Our ref: 51117-LT01-A
Your ref: MCU/2026/222
Contact: Alex Williams

Response to Council Information Request – Application Number MCU/2026/222
Proposed Mixed Use Development – 60 Kortum Drive, Burleigh Heads

60 KORTUM DRIVE, BURLEIGH HEADS
PROPOSED MIXED USE DEVELOPMENT

DRAWING TITLE: **SITE PLAN**

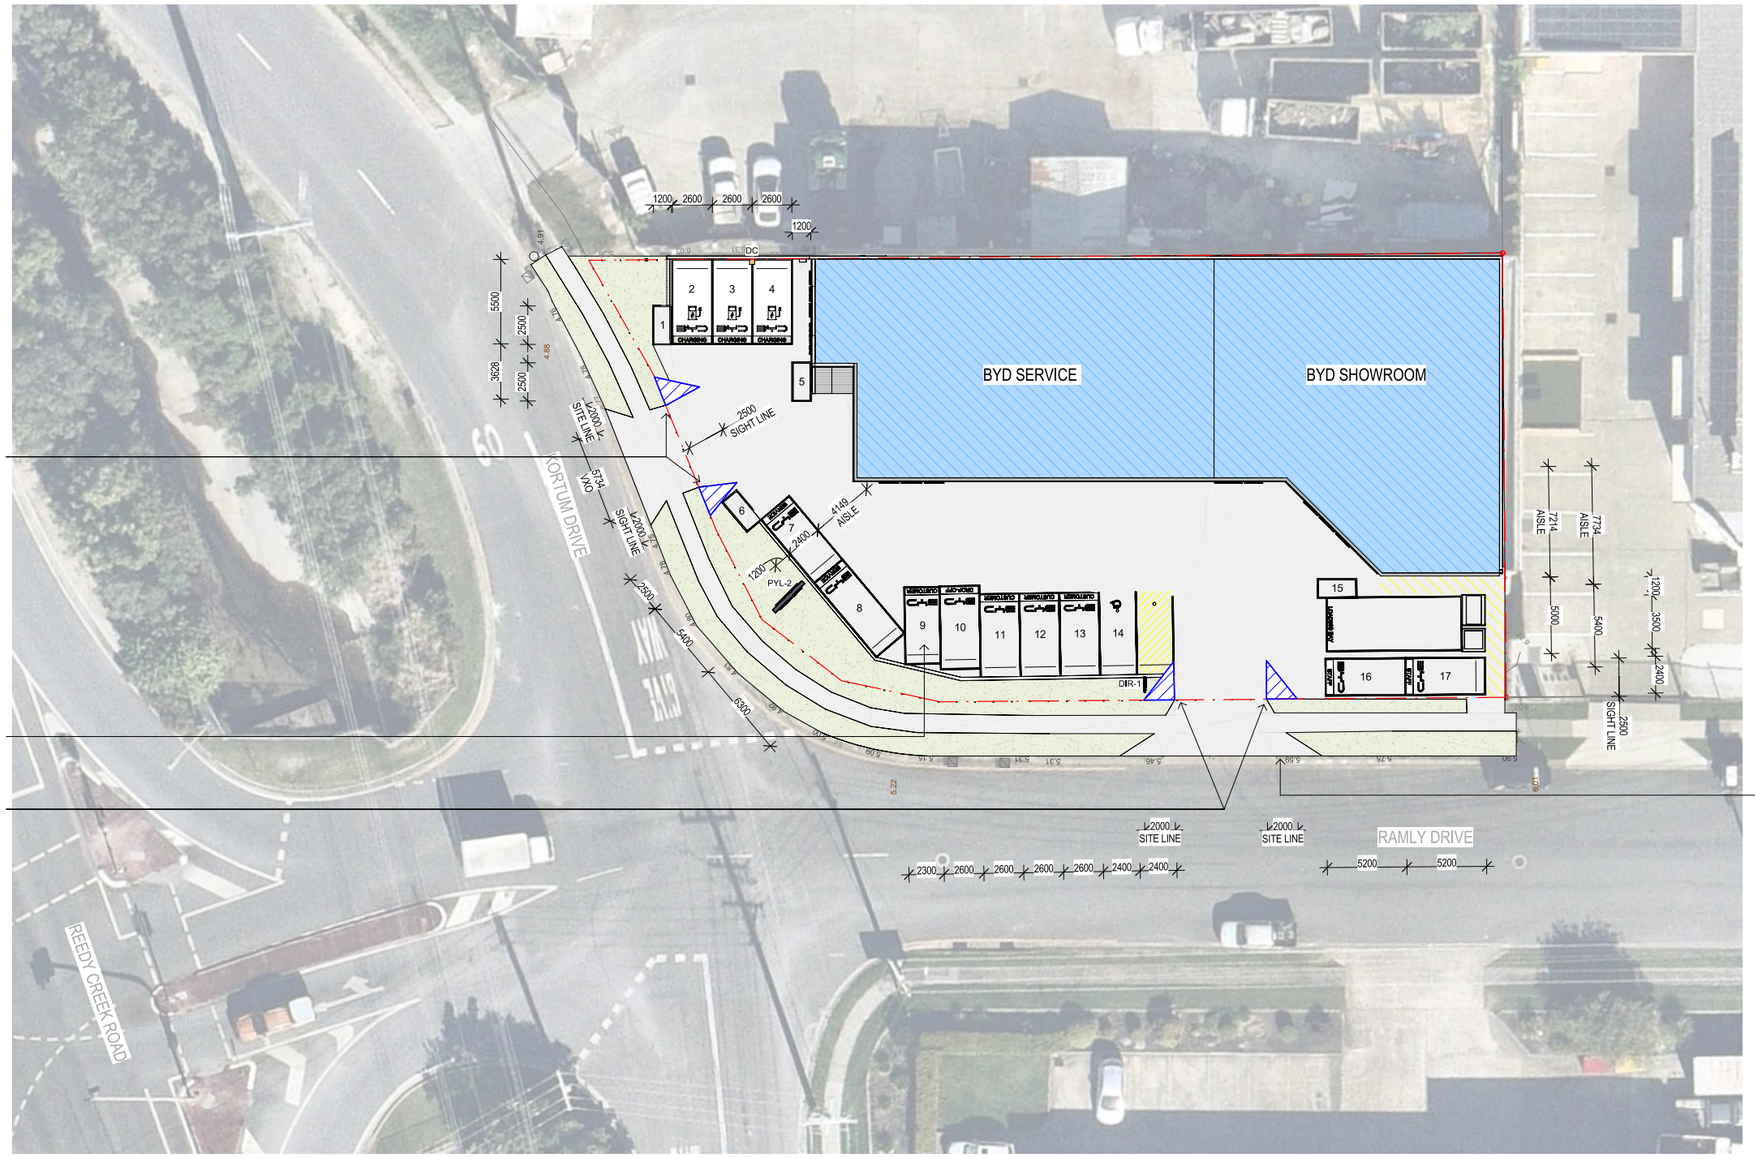
The submitted plans do not provide a dedicated pedestrian access to the site, with access only available via the vehicle crossing/access driveway points. To comply with AO8.1, AO8.2 and AO8.3 of the Transport code, the applicant is requested to provide a clearly defined, accessible pedestrian pathway from Ramly Drive to the Showroom entrance, separated from vehicle access.

The plans of development have been updated to clearly define the pedestrian access point separately from the vehicle crossings. The pedestrian access point provides a direct and unobstructed route to the showroom entrance, without requiring pedestrians to navigate through the car park.

The updated plans of development, depicting the pedestrian access point, are included in **Attachment B**.

DRAWING TITLE: **FUNCTIONAL AREA PLAN**

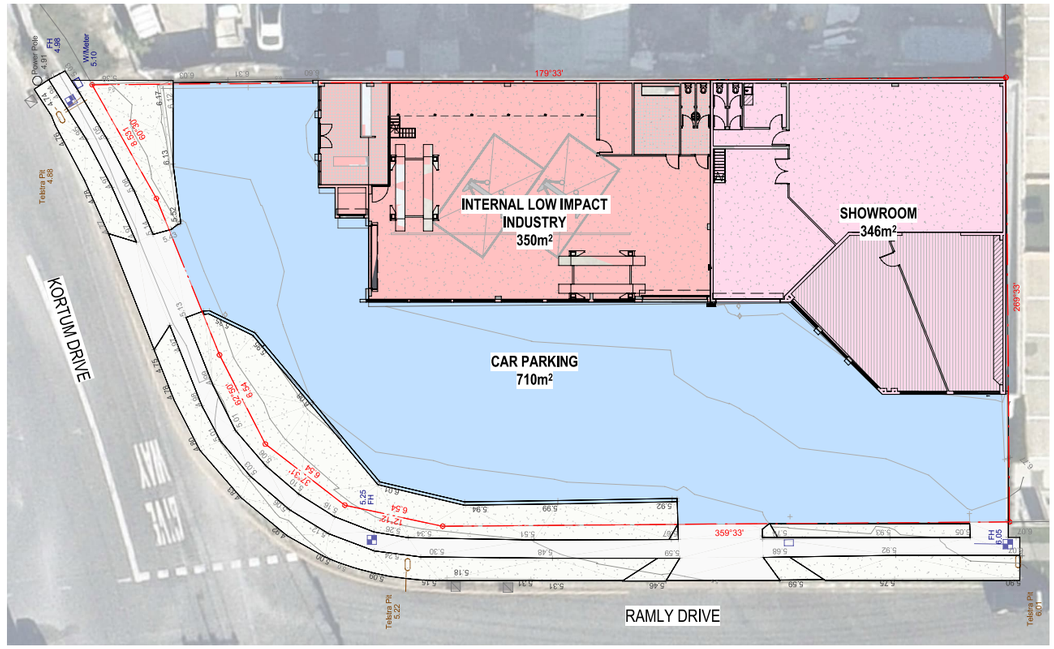
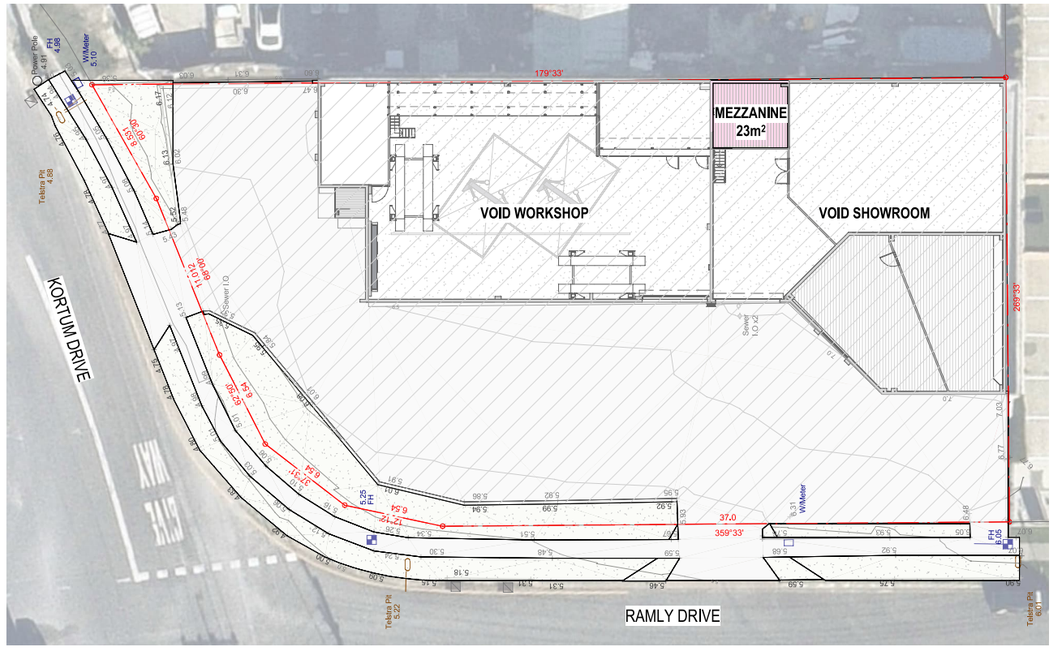
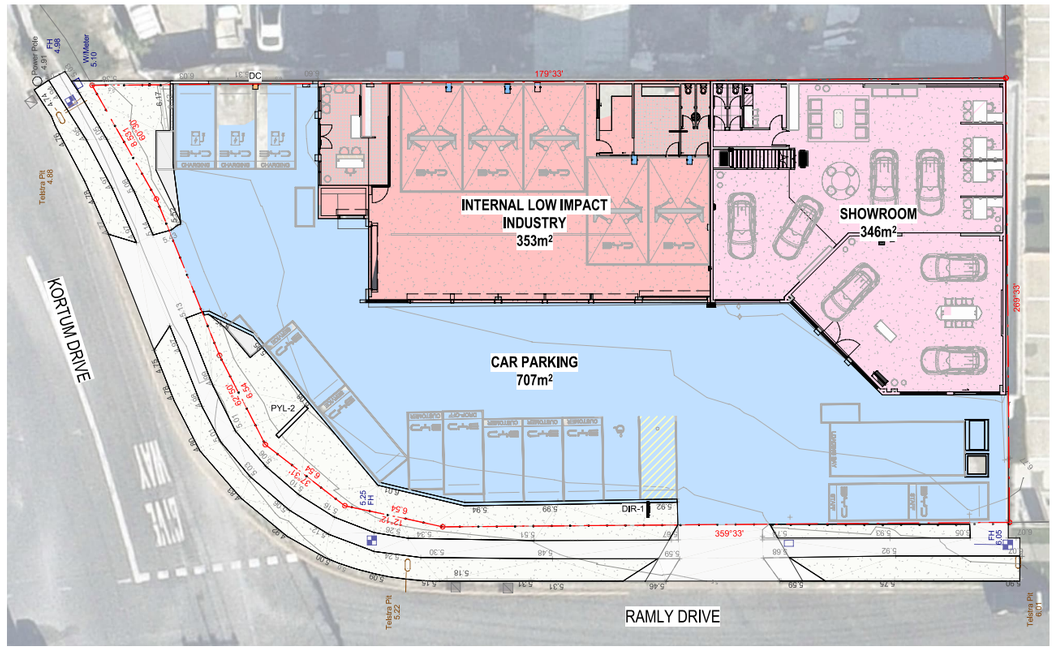
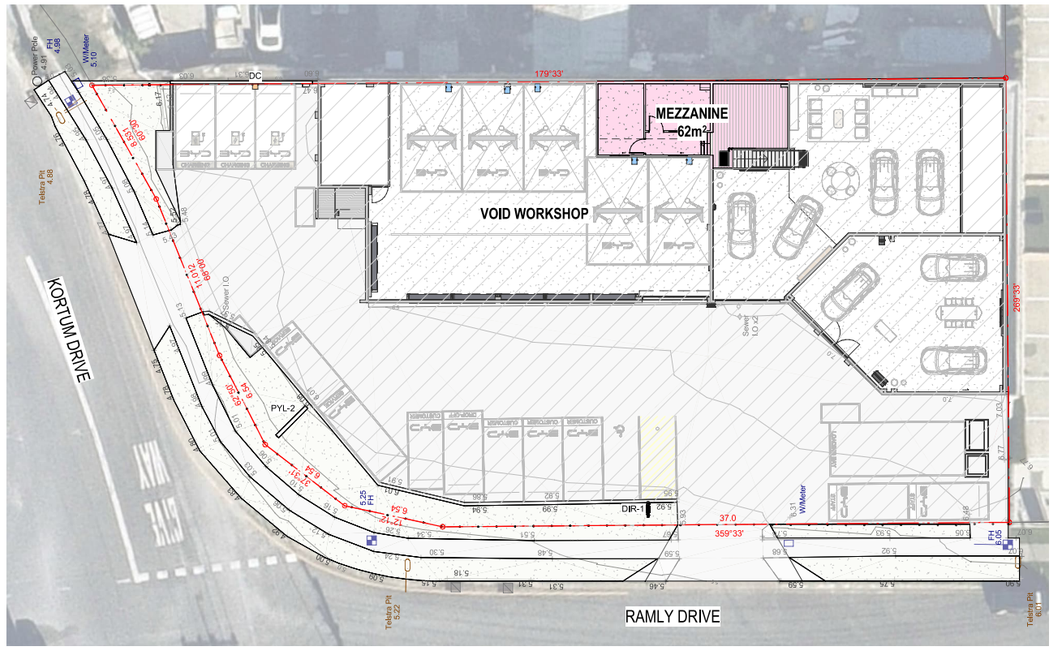
The submitted 'Functional Area Plan' drawing identifies the car parking and vehicle circulation/manoeuvring area for the purpose of 'Outdoor Showroom'. Noting this area is required to accommodate the developments car parking, the applicant is therefore requested to remove reference to 'Outdoor Showroom' from the drawing.

The plans of development have been updated to remove the reference to the Outdoor Showroom land use. Updated plans of development are included in **Attachment B**.

SWEPT PATH ASSESSMENT
8.8m MEDIUM RIGID VEHICLE (MRV)
EXIT FROM DEVELOPMENT SITE

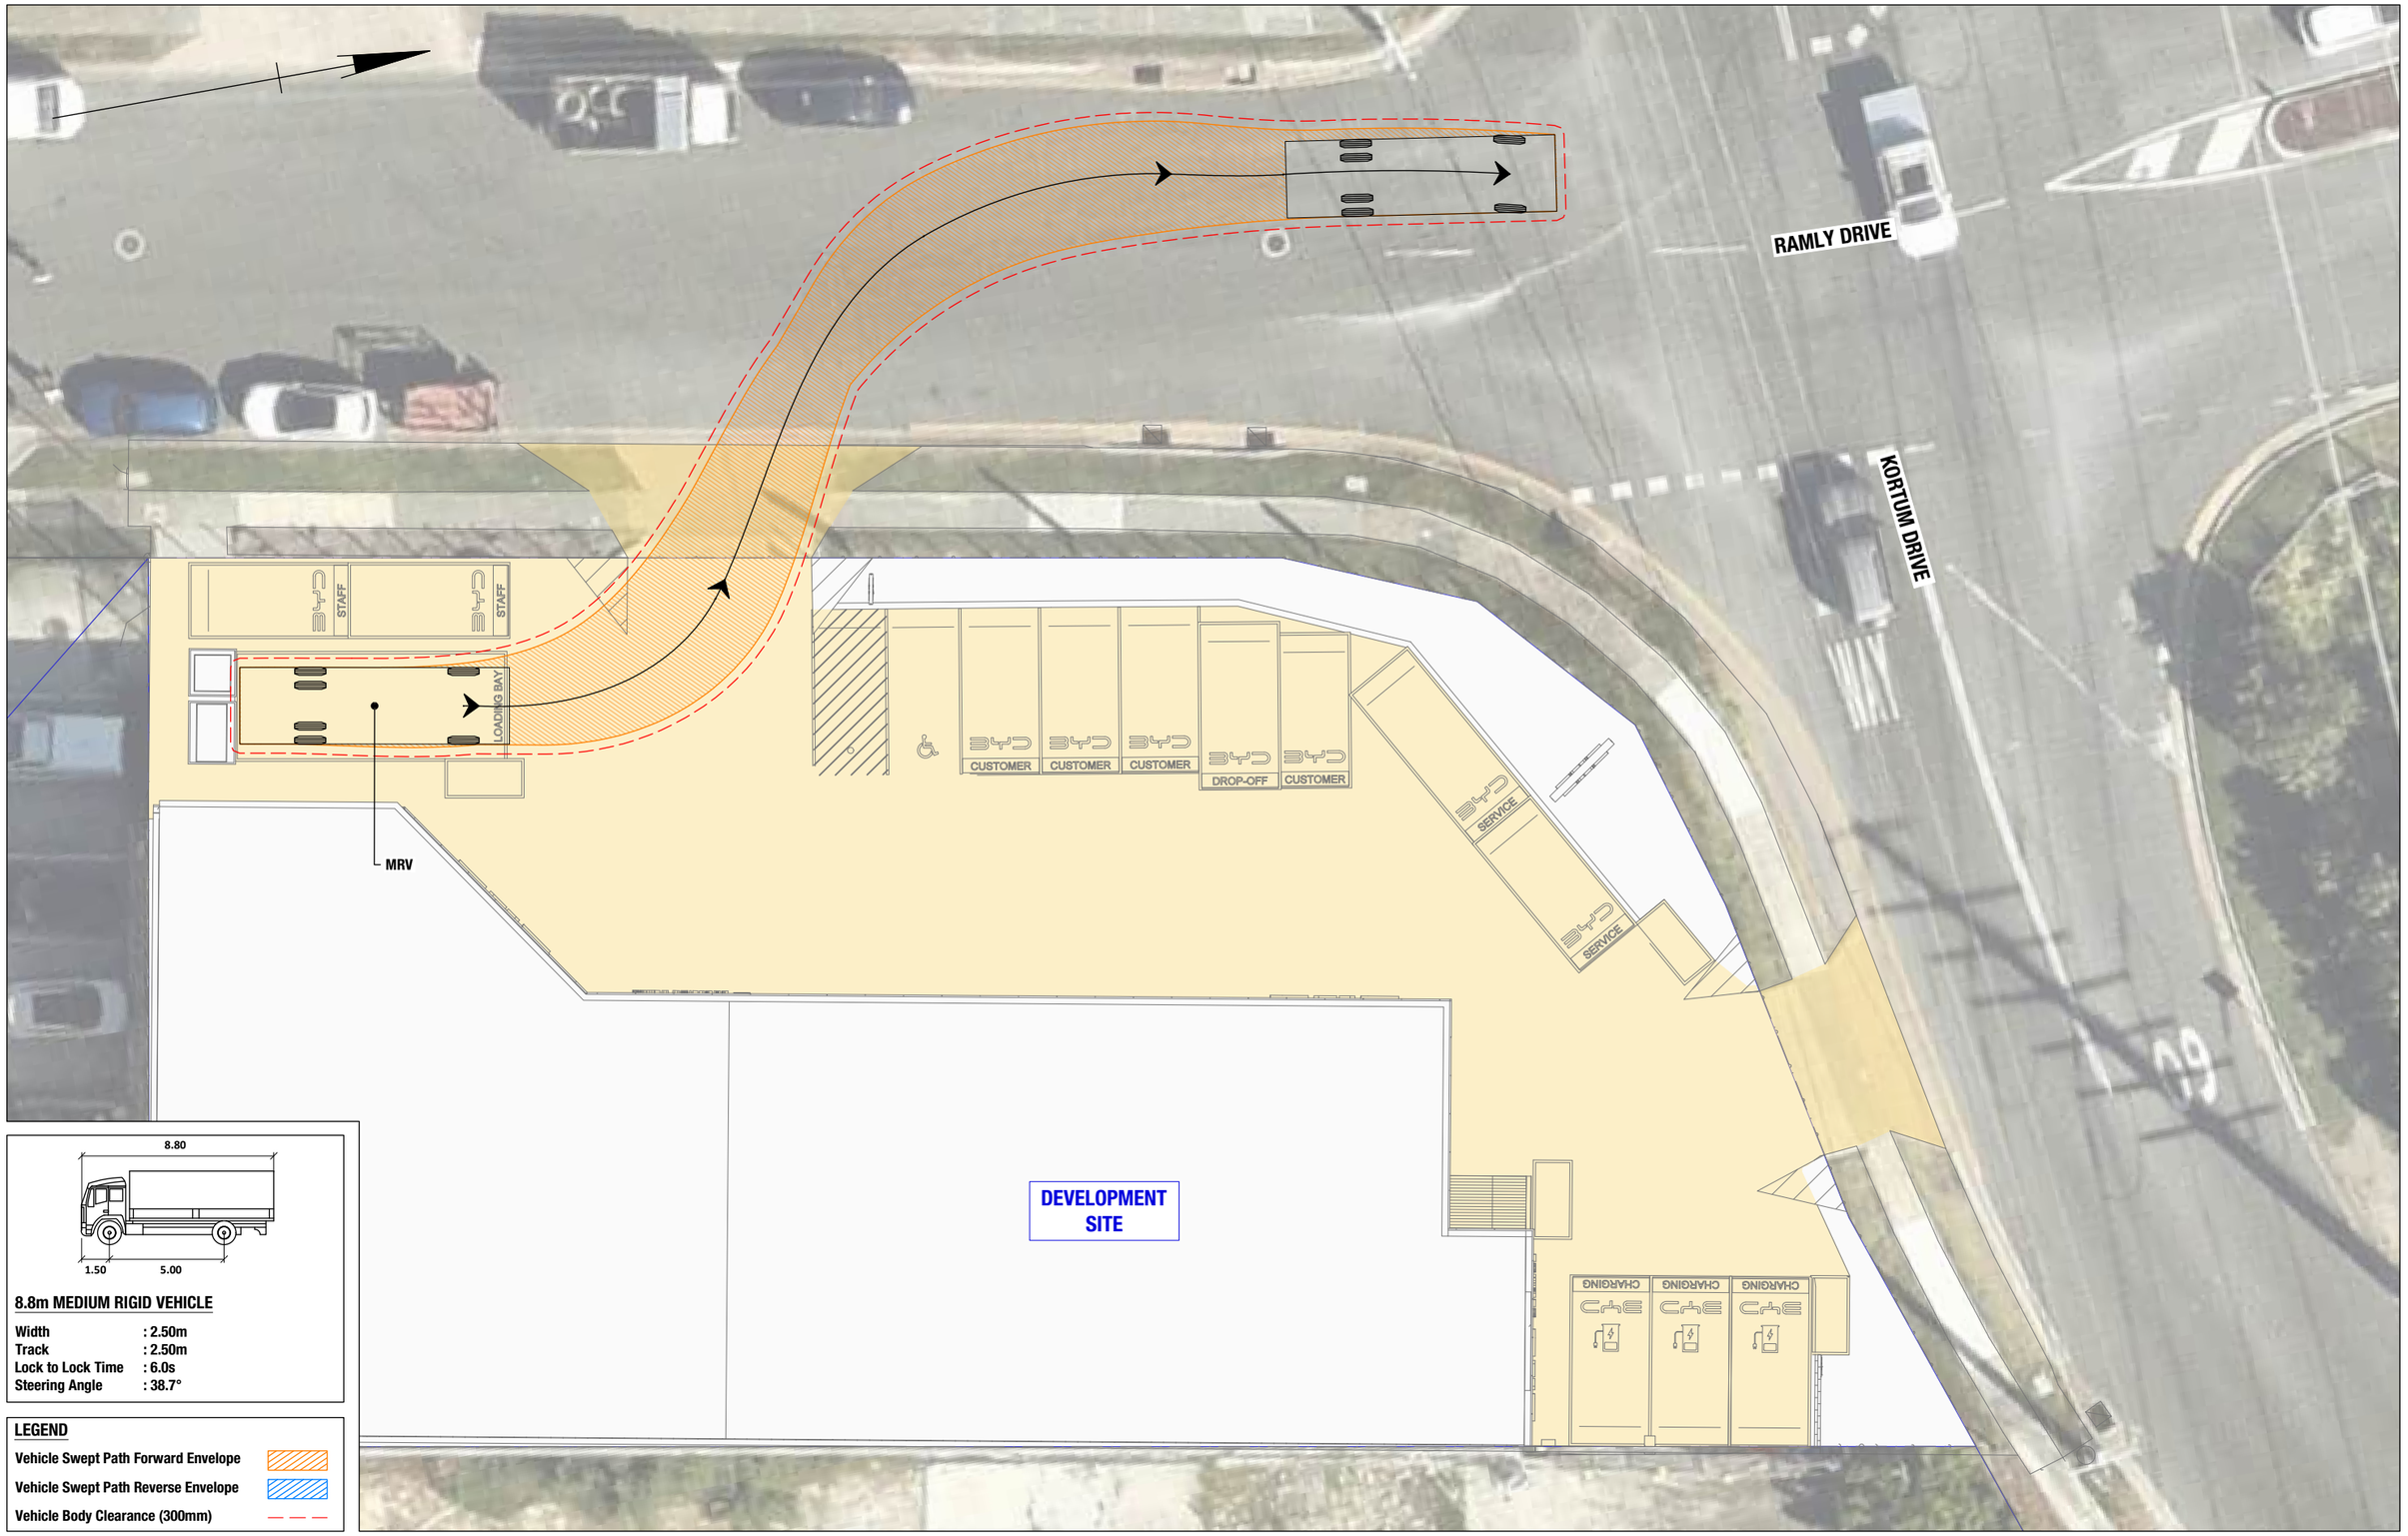
There is insufficient space on site for large service vehicles to safely manoeuvre. The submitted plans do not demonstrate how service vehicles will be accommodated within the site. Officers consider that vehicles may be delivered to the proposed Showroom by 20m Articulated Vehicle (AV) car carriers.

To demonstrate compliance with PO3 of the Transport code, including Tables 9.4.13-8 (Service vehicle requirements) and 9.4.13-9 (Minimum class of service vehicle), the applicant is requested to submit amended plans showing the following:

i. A service bay capable of accommodating a 20m AV. The service bay must be located wholly within the site and must not obstruct access to car parking spaces.

iii. All other service vehicles (i.e. Van, Small Rigid Vehicle (SRV) and Medium Rigid Vehicle (MRV)) must be able to enter, manoeuvre and exit the site entirely within the site.

Advice provided by the Applicant confirms that the proposed development will operate as a small-scale vehicle sales and servicing facility. Vehicles associated with the business are predominantly stored at an off-site holding facility, with vehicles transferred to and from the subject site as required. The Applicant has advised that these transfers are generally undertaken using a tow truck consistent with the dimensions of an 8.8m Medium Rigid Vehicle (**MRV**).

Accordingly, the site layout and servicing arrangements have been designed in accordance with *AS2890.2* and Council's *City Plan – Transport Code (V13)* for vehicle sizes up to an MRV. A dedicated loading area is provided within the site that can accommodate vehicles up to an MRV without impacting the operation of the site or external road network (**Attachment B**).

A swept path assessment has been undertaken using AutoTURN, demonstrating that vehicles up to an MRV can enter the site in a forward gear, access the designated loading area and depart the site in a forward gear. Swept path analysis has also been completed for a 10.2m front loading refuse collection vehicle (**RCV**), confirming that waste collection vehicles can safely access and service the development. The swept path assessments are included in **Attachment C**.
